SERVICE BULLETIN

MODEL NAME : Di620
MODEL CODE : 1155
NO. : 030A
DATE : 990408
SUBJECT : PROVISIONS FOR NEW BLUE ANGEL MARK

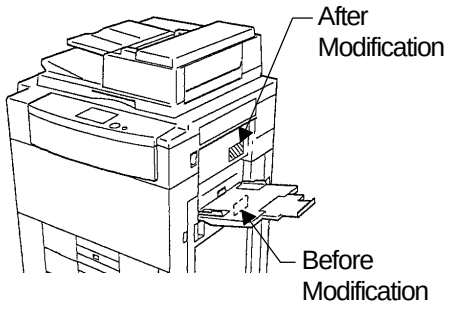
The following modifications have also been made.

- The location to which the maker plate is affixed has been changed.

- The identification labels shown below are separately dispatched, not shipped with the product (not affixed to the product). Be sure to affix the identification labels (07, 09) of PS to the product that has undergone this modification.

Before Modification	After Modification
Material	Polyester film	PS
